SP 2-235-004
SERVICE PROGRAM

Installation of Tru-Flex exhaust pipe.

This Service Program provides information and instructions for the installation of the Tru-Flex 4-inch exhaust pipe on certain exhaust configurations of MY 2014 to 2018 Xpeditors.

Figure 1

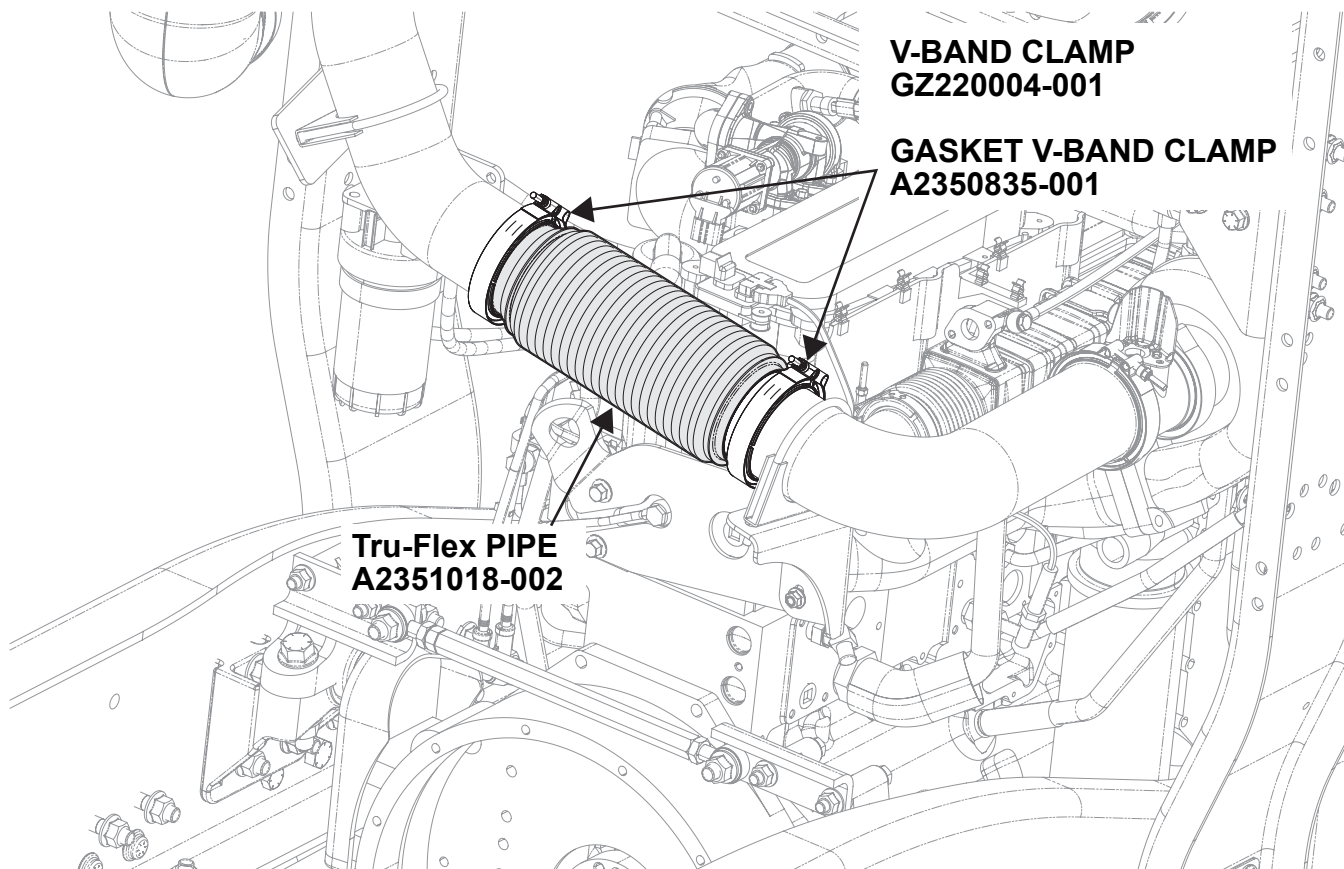
2. Remove the existing flex pipe, clamps and gaskets and discard.
3. Install the new gaskets (A2350835-001) on each end of the new Tru-Flex pipe (A2351018-002) (see *Figure 1*).
4. Install the new Tru-Flex pipe (with gaskets) to the exhaust pipe (see *Figure 1*).
5. Install the new V-Band clamps (GZ220004-001) and tighten to 12 Lbs.-Ft. (16 N-m) of torque (see *Figure 1*).
6. Lower the cab.
7. Installation is complete.
